# Access Compliance Report

## Public Rights-of-Way

### (Curb Ramps)

Intersection ID: 48826	Main Street: DISCOVERY_LN	Cross Street: PLEASANT_GROVE_RD	Location: SW
ADA ID: 2A5638385F75	Ramp Type: Perp	Initial Pass/Fail: Fail	Overall Compliance: No
Severity Score: 10			
Codes/Mitigation Info/Possible Solution		Field Measurements/Component Compliance

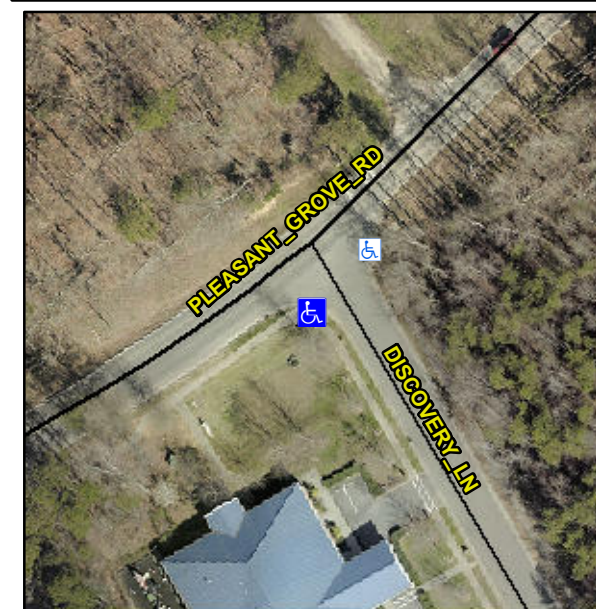
**Not Found, R304.5.1, R304.5.3**

Compliance	Description	Data	Compliance	Description	Data
N/A	Ramp Length (in)	47.0	Yes	Ramp Slope (%)	5.5
No	Ramp Width (in)	47.0	No	Ramp XSlope (%)	2.1
N/A	Flare Type LT	N/A	N/A	Flare Type RT	N/A
N/A	Flare Slope LT (%)	N/A	N/A	Flare Slope RT (%)	N/A
N/A	Flare Traversable LT?	N/A	N/A	Flare Traversable RT?	N/A
N/A	Landing Length (in)	N/A	N/A	DWS Provided?	N/A
N/A	Landing Width (in)	N/A	N/A	DWS Contrast?	N/A
N/A	Landing Slope (%)	N/A	N/A	DWS Length (in)	N/A
N/A	Landing X Slope (%)	N/A	N/A	DWS Full Width?	N/A
N/A	Landing Curb? (Y/N)	N/A	N/A	DWS Offset (in)	N/A
N/A	Shared Landing?	N/A			
N/A	Gutter Ponding?	N/A	N/A	Gutter Slope (%)	N/A
N/A	Gutter Lip Ht (in)	0.5	N/A	Gutter X Slope (%)	N/A
N/A	Painted X Walk1?	No	N/A	Painted X Walk2?	N/A
	X Walk 1 Direction	To NE		X Walk 2 Direction	N/A
N/A	X Walk 1 Width (in)	N/A	N/A	X Walk 2 Width (in)	N/A
	X Walk 1 Slope (%)	0.2		X Walk 2 Slope (%)	N/A
	X Walk 1 X Slope (%)	0.5		X Walk 2 X Slope (%)	N/A

**Remove & Replace Entire Ramp.**
